**TRANSPORT AND WORKS ACT 1992**  
**NETWORK RAIL (HUDDERSFIELD TO WESTTOWN  
(DEWSBURY) IMPROVEMENTS) ORDER**

**STATEMENT OF COMMON GROUND**  
***NETWORK RAIL INFRASTRUCTURE LIMITED & THE  
ENVIRONMENT AGENCY***

Document Reference	NR/SOCG/2
Date	December 2021

Figure 4-7 Red Doles culvert extension located in FZ1 (Dark Blue 1% AEP flood outline/Light Blue is the 0.1% AEP flood outline).

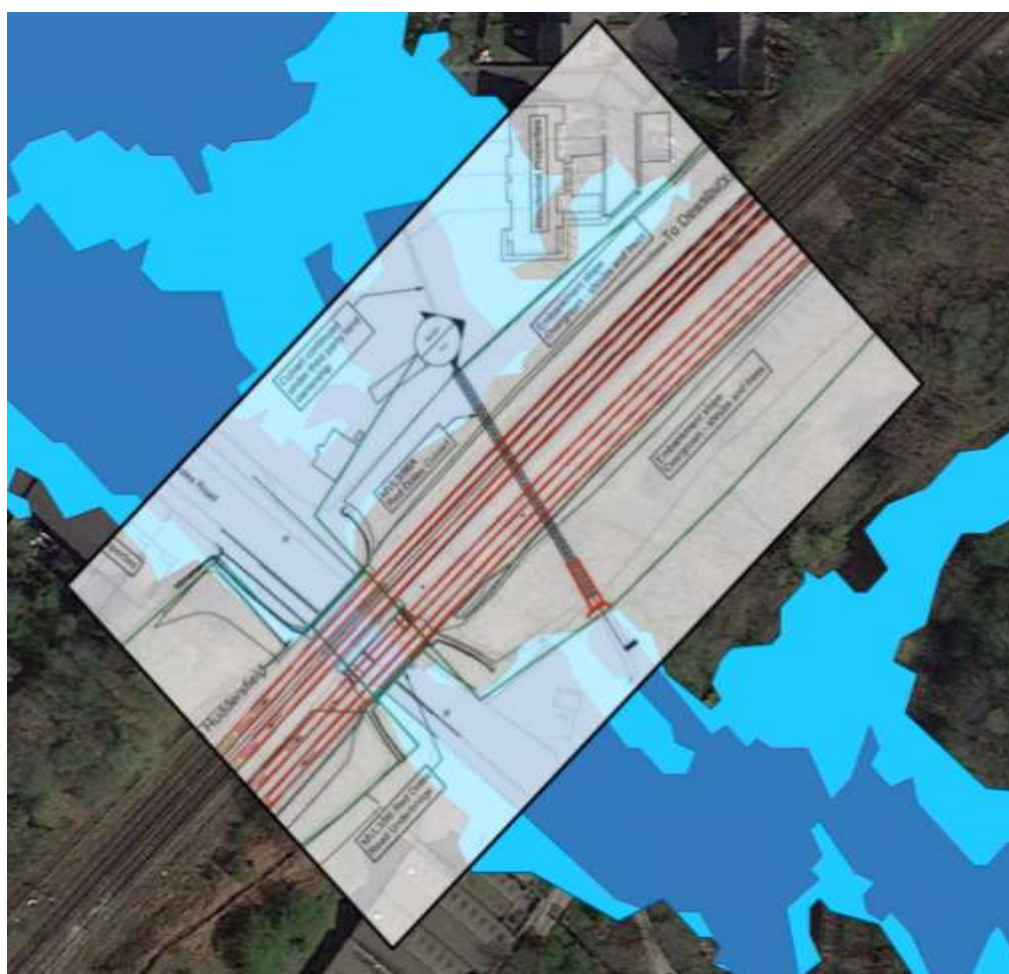
5.1.2 The EA raised a specific question of clarification regarding the approach in the FRA to the assessment of flood risk along Blackhouse Dyke (situated in Route Section 2). NR set out its approach to the modelling of Blackhouse Dike in the absence of any flood level data being available for this watercourse in the existing River Colne model. Further clarification was provided verbally to the EA to agree the approach to using design flow data for the assessment of risk to and from the development associated with increased flows attributed to climate change to support the FRA conclusion that no flood risk arises in relation to the Blackhouse Dyke from the Order works. The approach taken was agreed with the EA and will be formally reflected in the flood risk assessment clarification document. NR and the EA agree that this is an acceptable way to proceed and so this matter does not constitute a matter outstanding for the purposes of this document.

**4.5.154.5.18** Blackhouse Dike flows beneath the railway at Red Doles Culvert (MVL3/96A). This culvert will be extended by approximately 10m downstream of the existing railway crossing to accommodate embankment widening works near Red Doles Road. These embankment widening works are required in relation to the engineering works to provide 4 tracks in this section of the railway corridor. The embankment widening works are confined to the works around the extension of the culvert outlet which, in addition, are located within FZ1 and are outside of FZ2 and FZ3 (see Figure 4-7).

**4.5.164.5.19** In the absence of any specific flood model data for Blackhouse Dike, this FRA has made an assessment on the likely extent of climate change outline using design flow extracted from the River Colne Model. The River Colne model has Blackhouse Dike represented as a direct inflow. The 1% AEP flow from Blackhouse Dike is 23.57m<sup>3</sup>/sec and the 1% AEP +CC flow is 35.35m<sup>3</sup>/sec, with the 0.1%AEP flow at 43.15m<sup>3</sup>/sec. In the absence of any modelled flood level data we can assume that the CC flood outline is in between the 1% and the 0.1% flood outline as shown below, indicating that the works associated with the headwall are within FZ1 and outside of the 1% AEP+CC.
